I strongly object on the basis of biodiversity issues to the development project SSD-9679 “Hills of Gold Wind Farm” consisting of 64 wind turbines in the Nundle, Crawney and Hanging Rock district of Northern New South Wales.

Turbine placements adjoining Ben Halls Gap Nature Reserve

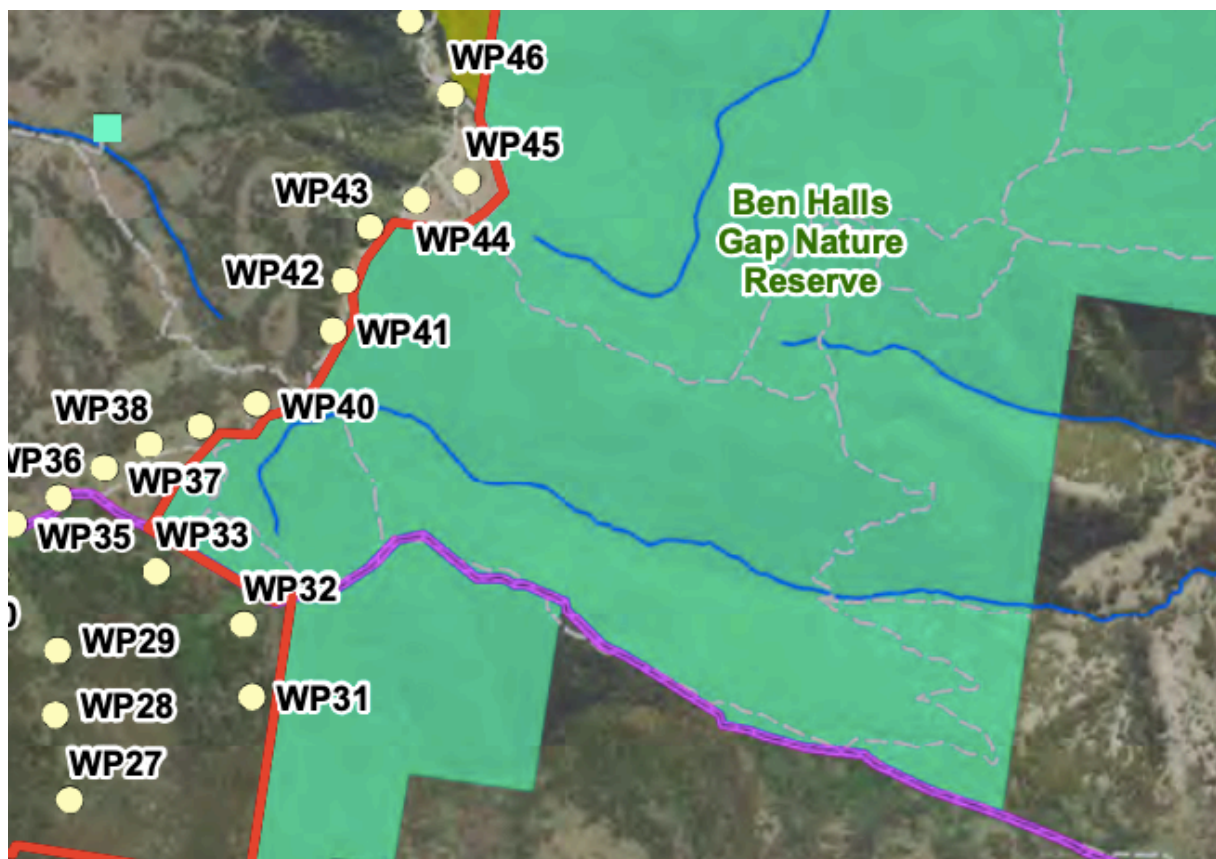
The map below highlights the proposed distances and extreme proximity of turbine placements to the boundary of the reserve.

Turbine 31 : 180 metres
Turbine 32 : 205m
Turbine 33 : 207m.
Turbine 38 : 178m
Turbine 39 : 137m.
Turbine 40 : 99m
Turbine 41 : removed
Turbine 42 : 87m.
Turbine 43 : 88m.
Turbine 44 : 177m.
Turbine 45 : 113m

Question 3: Given Upper Hunter Shire Council’s Development Control Plan requirement of 460 metres (2 x 230 metres proposed turbine height) distance from non-associated boundaries why are all 10-turbine placements surrounding Ben Halls Gap Nature Reserve less than 45% of the requirement from the boundary?
